***JAPAN's Comments on
Backset Requirements of
FMVSS 202aS
Final Rule***

GRSP INFORMAL WORKING GROUP ON HEAD RESTRAINTS

JAPAN MLIT

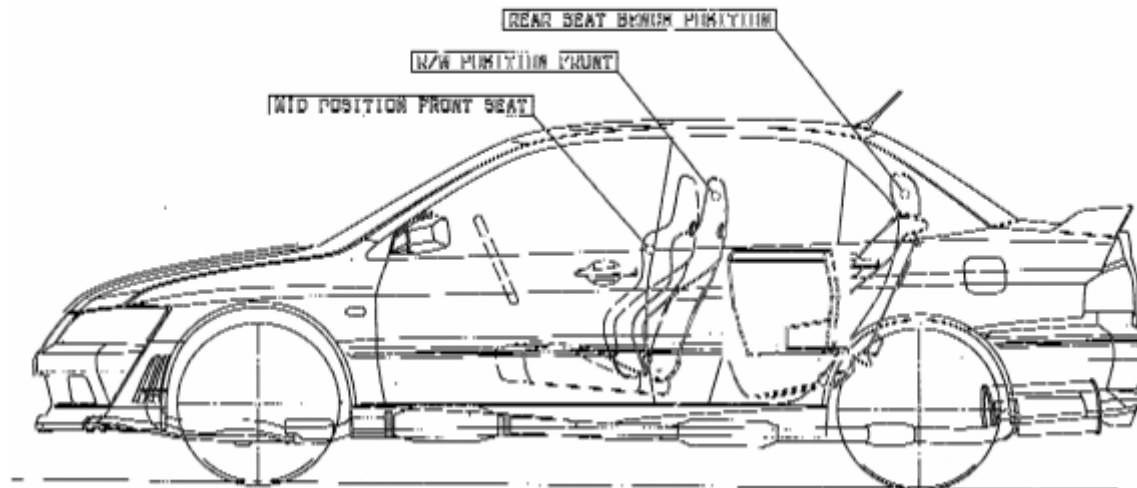
- (3) Vehicle posture variation also makes torso angle and Backset measurement variation, because the posture is not specified in FMVSS202.

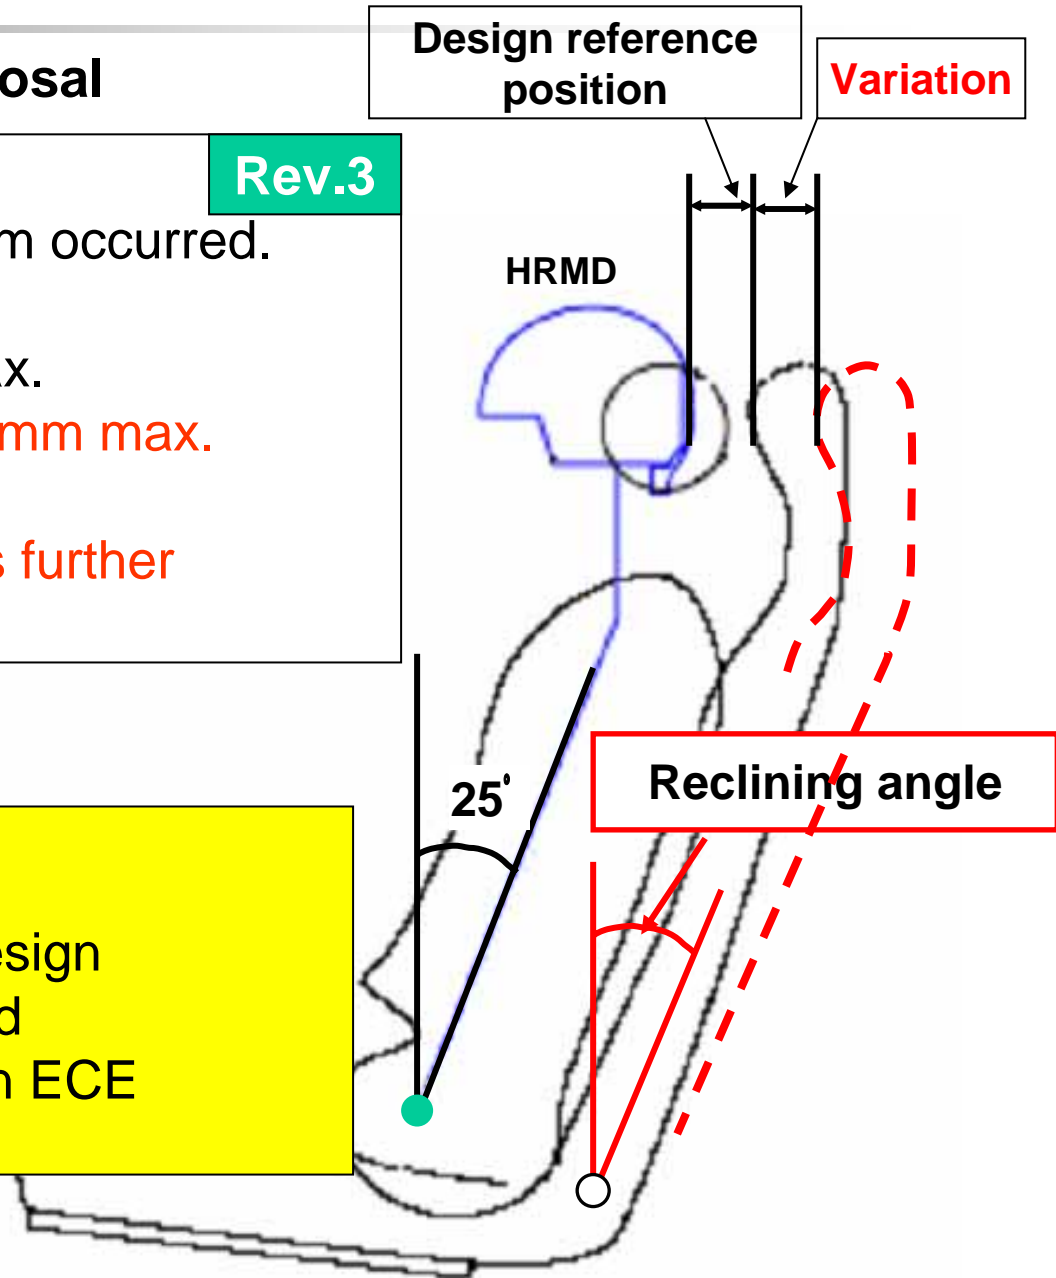
(5) Summary and Proposal

A maximum variation of 29.0 mm occurred.

- Measurers variation: 4.0 mm max.
- **Reclining angles variation: 29.0 mm max.**

Vehicle posture variation makes further variation.

<Proposal>

To measure backset at the design reference position (with a fixed reclining angle) as specified in ECE

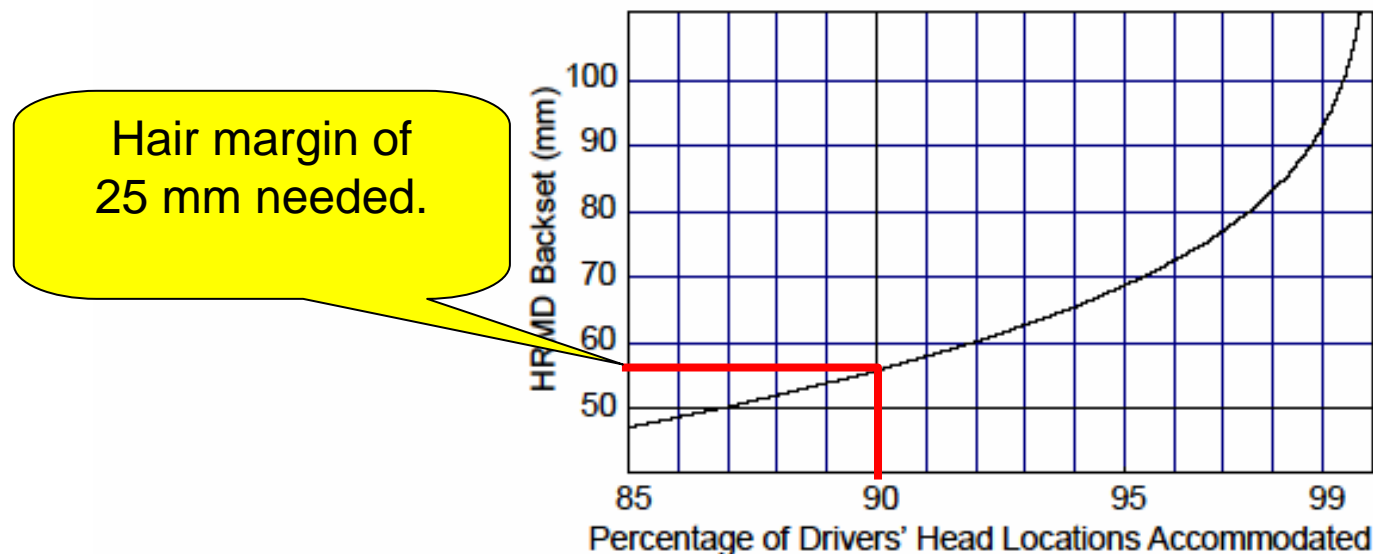
(2) Regarding the figure referenced by NHTSA (shown below), UMTRI clearly states that a **hair margin of 25 mm** is needed.

If head restraints complying with the NPRM were added to current driver seats, the head restraints would interfere with about 13 percent of drivers preferred head positions. The head restraints would contact the hair of about 33 percent of drivers, assuming a median hair margin at the back of the head of 25 mm. Figure 3 shows the percentage of drivers
